DESIGN/DEVELOPMENT REVIEW COMMISSION
DESIGN REVIEW DISTRICT
HISTORIC AGENDA
EVALUATION SHEET
Case # 1, Historic Consent Agenda

ADDRESS: 3219 Lyles Street

NATURE OF REQUEST: Request for Certificate of Design Approval for new construction

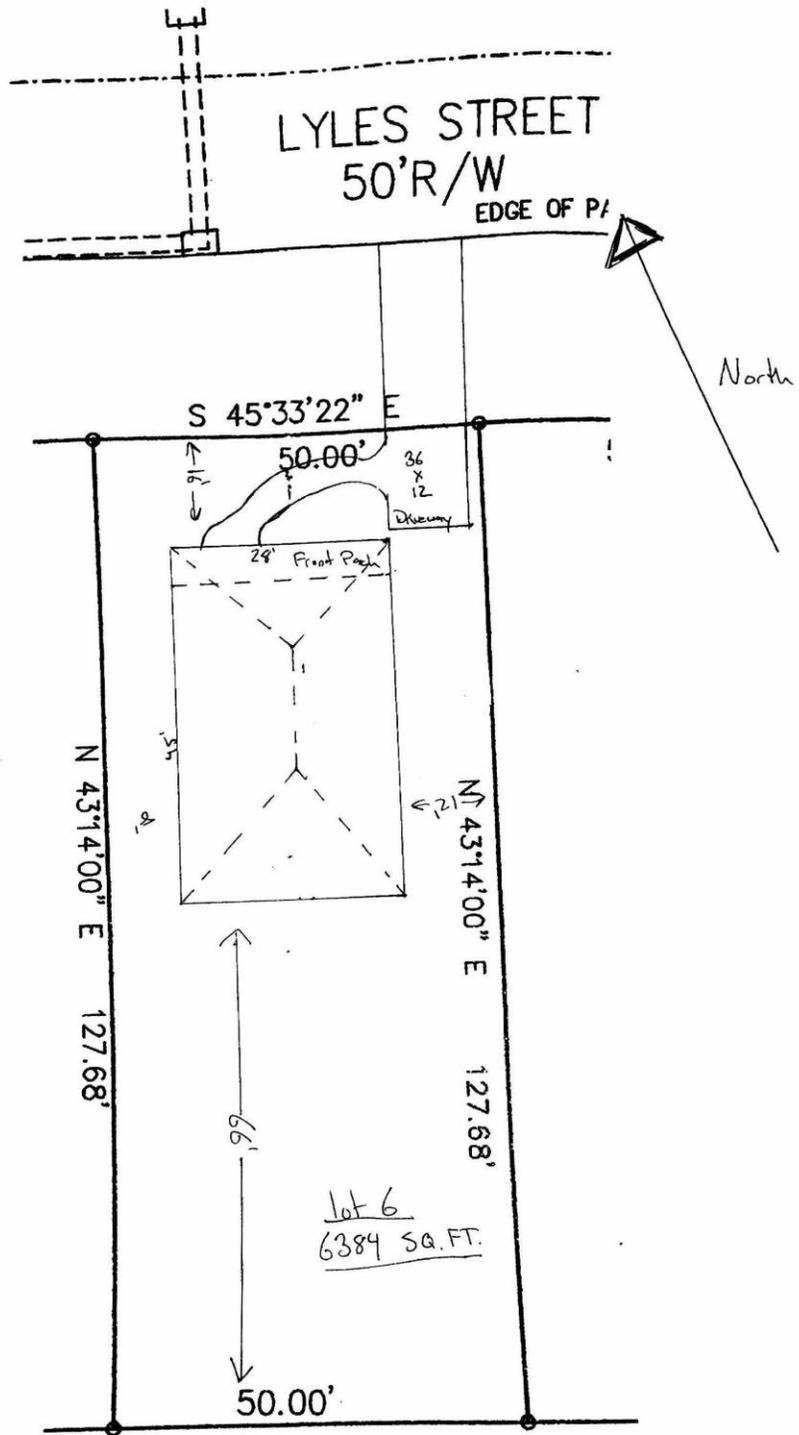
The enlarged site plan provided by the applicant indicates a concrete driveway pad along the right property line measuring 12'x36'. The width and length of the proposed driveway is in compliance with the guidelines

Proposed façade

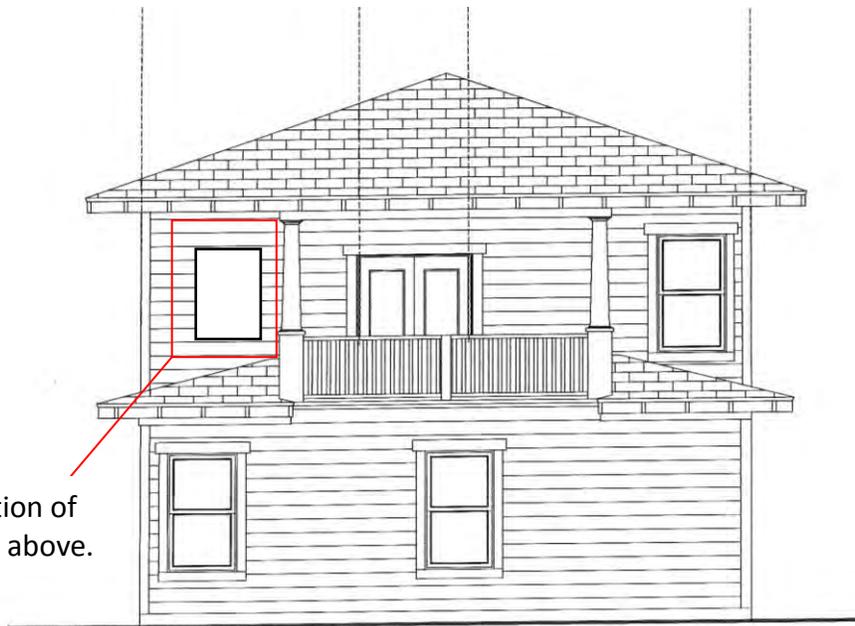
The front façade of the proposed new construction is broken into two bays through the use of three columns with brick piers. In one bay, there is a pair of double hung windows and in the second bay, the front door is centered between the columns. The distribution of solid components to open spaces across the front façade is compatible with historic buildings in the district and on the block.

The front entry consists of an engaged porch across the entire front façade. The doorway is centered between two columns on the porch, to make an asymmetrical facade. This porch style is compatible with the Earlewood Protection Area. The porch is supported by three square tapered columns on top of 2'6" wide brick piers.
